Final Interconnection Facilities Study Report

Request # GI-2006-1e

Facilities Study for the Squirrel Creek Energy Center

December 20, 2006

Figure 2: Interconnection Diagram³

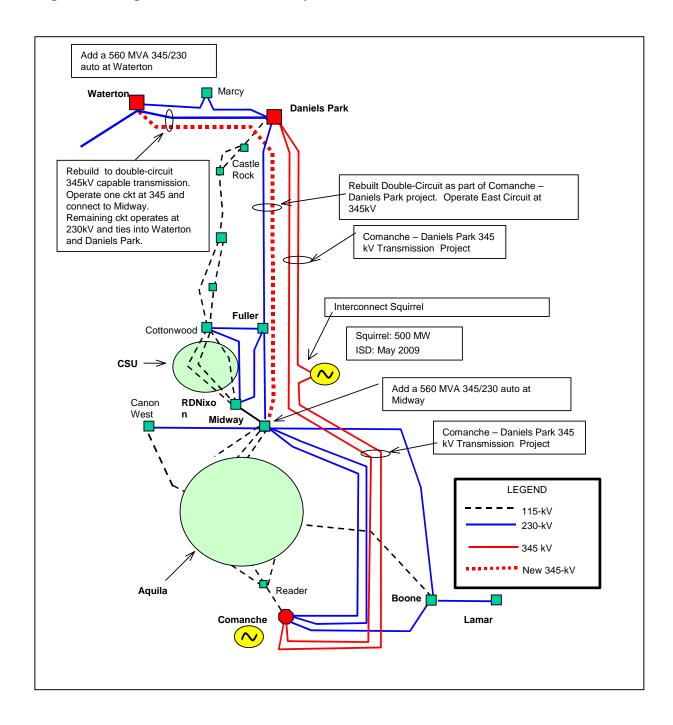
2. We would want to remove our Extra Breaker on our Radial Line. The high side breakers between the generator transformers and our switchyard would be used for intent purpose of protection between PSCo and Squirrel Creek. An air switch would be used instead of the breaker on the radial line to PSCo Switching Station for visual/safety isolation. Please see attached single line that identifies our proposed Squirrel Creek SWYD and Breaker locations.

PSCo Response: Xcel Energy Interconnection Guidelines require the configuration shown in Figure 2, which includes a high-voltage (345 kV) breaker on the transmission line entering the Customer station.
